CHALLENGER COMMUNITIES, LLC

GALLOWAY RESPONSE

WOODMEN FRONTAGE ROAD TURN LANE

PUBLIC IMPROVEMENT CONSTRUCTION PLANS

STREET IMPROVEMENT PLAN

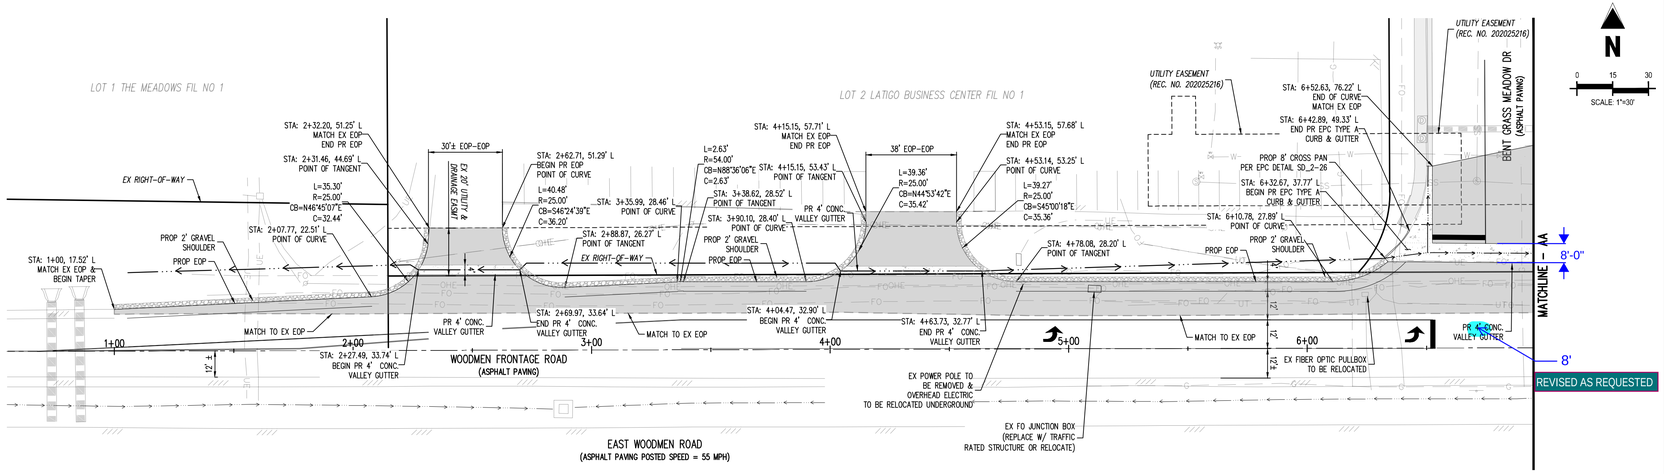
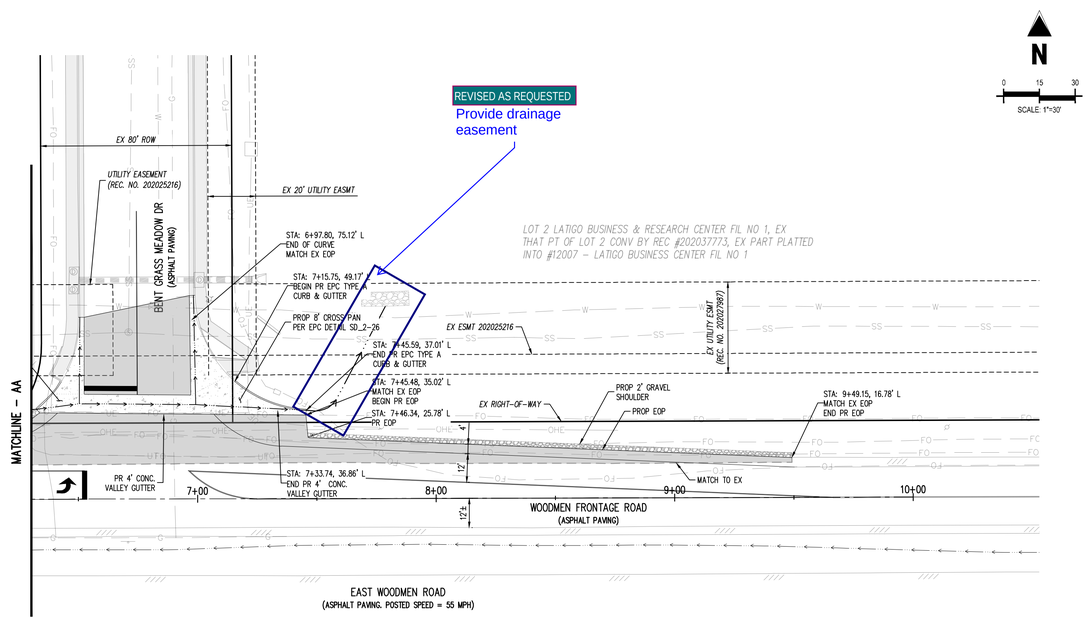
Per EPC Std Dtl SD_2-26, cross pan width needs to be 8'.

REVISED AS REQUESTED
